Address: 5024 Rainier Ave S, Seattle WA 98118 Owner: Duong Kiem Hung & Xuanthi Le Parcel No.: 564960-0120 Lot Size: 4401

Corrections Requested on 10/10/2024 LPB 279/24 Record # DONH-COA-01469

Corrections Requested on 11/05/2024 LPB 296/24 Record # DONH-COA-01469

Side View

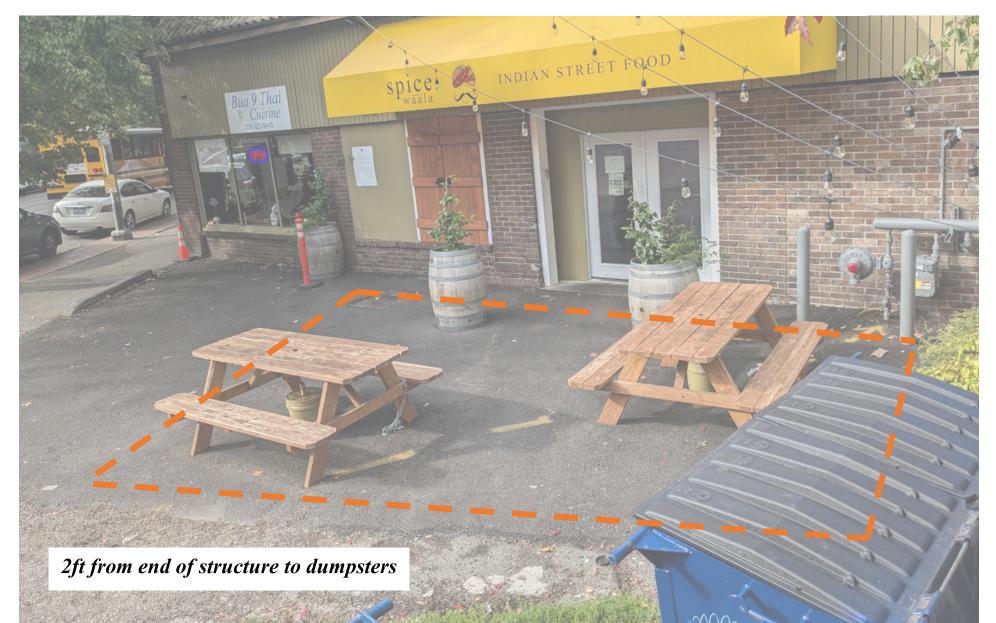
1. Please confirm the height of the structure.

The structure will be 7ft 6in high starting on the North side and sloping down towards the South ending in 7ft
